Groundwater Transfer Review Summary Form

Transfer/PA # T- 12926

Application: T-12926

Applicant Name: Horsefly Irr. District

Attachment A: Water Well Report for KLAM 12457

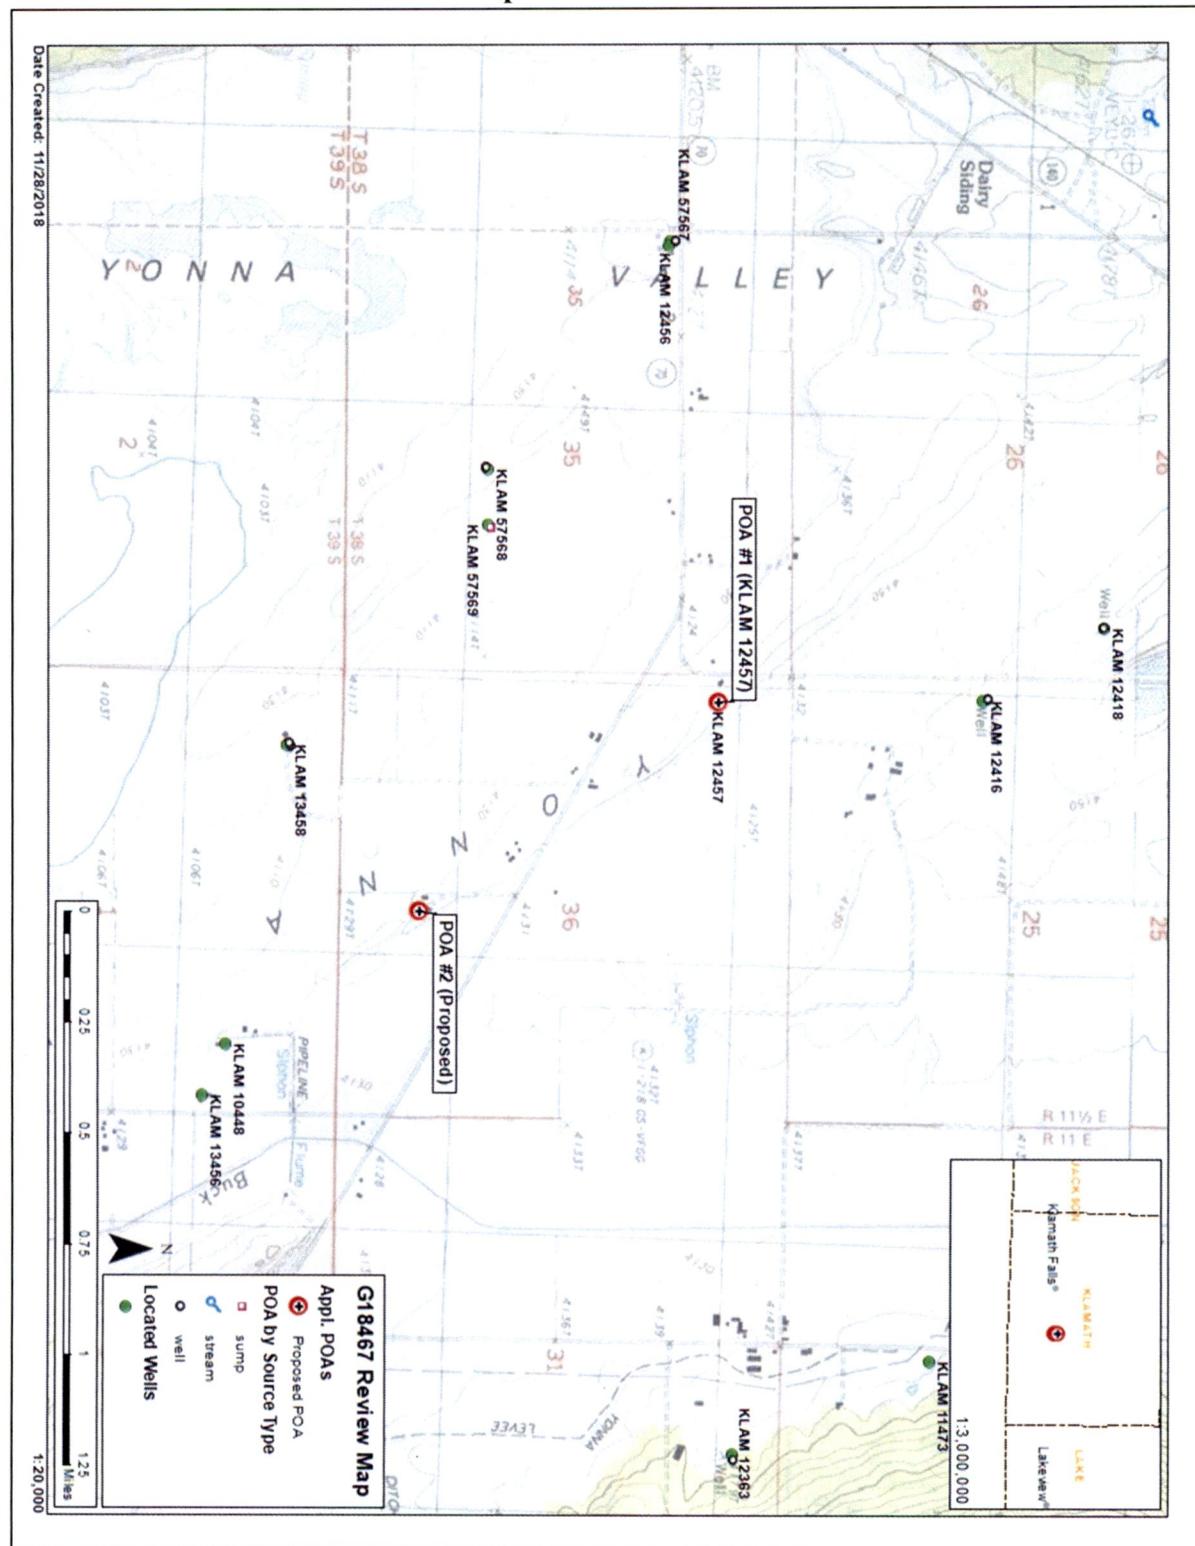
5. Any additional comments: The well report for the existing POA, KLAM 12457, is insufficient to interpret well construction and provides no record that minimum well-construction standards have been met. Also the reported 30 ft of casing is likely allowing for comingling between the shallow sedimentary aquifer zone and deeper volcanic-rock aquifer zones.

Attachment C: Modeled interference to nearby well KLAM 13458 from a) the existing POA and b) the APOA. Scenario T2S1 represents optimal model parameters.

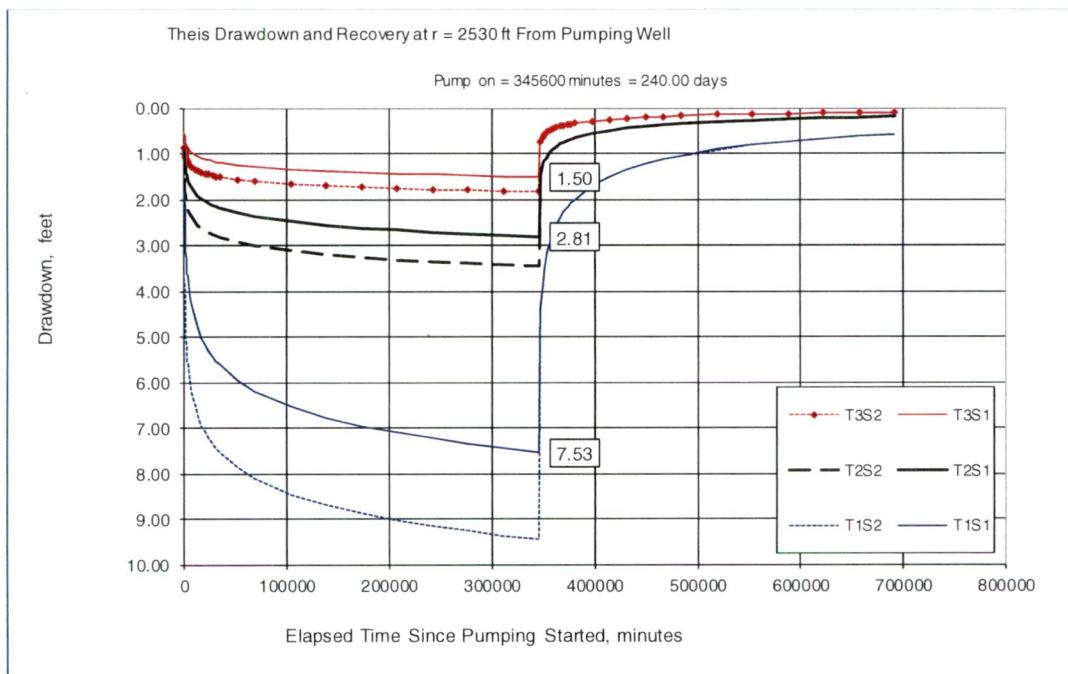
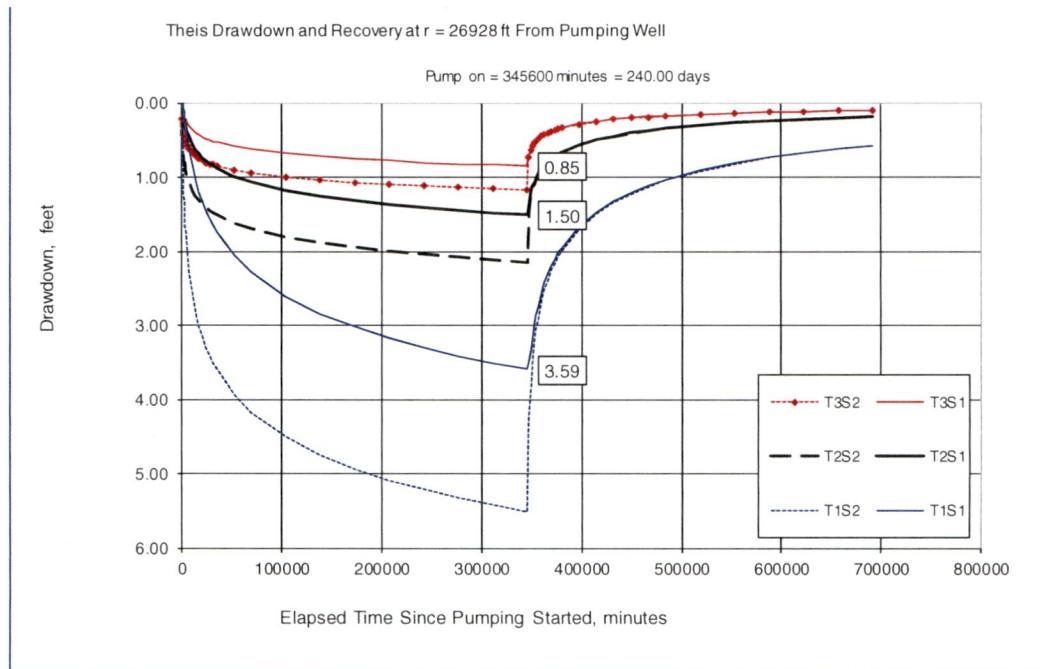
(1) The proposed APOA will be located approx. 0.5 miles closer to well Klam 13458 which is the POA on certificates 46871, 52214, 67509, 83017, and 83018. The closer distance with the new APOA will increase interference.

(1) Transmissivity values for the deeper volcanic-rock aquifer zones are reported to be 10^4 - 10^5 ft²/day and drawdown modeling (see Attachment C) suggests that maximum increases in interference caused by the proposed transfer will be < 0.5 ft by the end of the irrigation season.

Attachment D: Modeled interference near Bonanza Big Springs

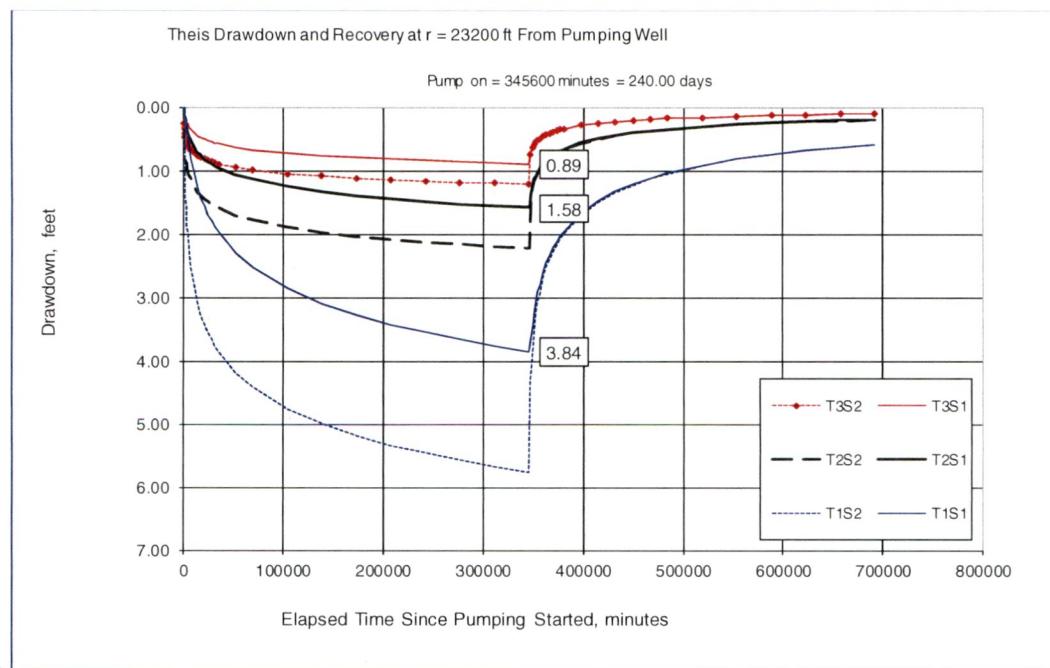
(2) Using the same model values, the increase in drawdown at Bonanza Big Springs caused by the proposed change would be < 0.1 ft by the end of the irrigation season (Attachment D). Day-to-day fluctuations in the stage-groundwater relationship at Bonanza Big Springs are approx. 0.1 ft and this review finds that the additional drawdown caused by the proposed change is **not significant**.

The following figures present modeling results of drawdown near Bonanza Big Springs from a) the existing POA and b) from the proposed APOA. The model uses three different transmissivity values and two different storage values that capture the range of values reported by Grondin (2004). According to Grondin (2004), interference to the actual springs is about 0.75 of the modeled drawdown. Note that differences in drawdowns between (a) and (b) are less than 0.1 for Scenario T2S1 – which represents the optimal model parameters, and less than 0.25 for Scenario T1S2 – which represents the most-exaggerated model parameters (largest drawdown)
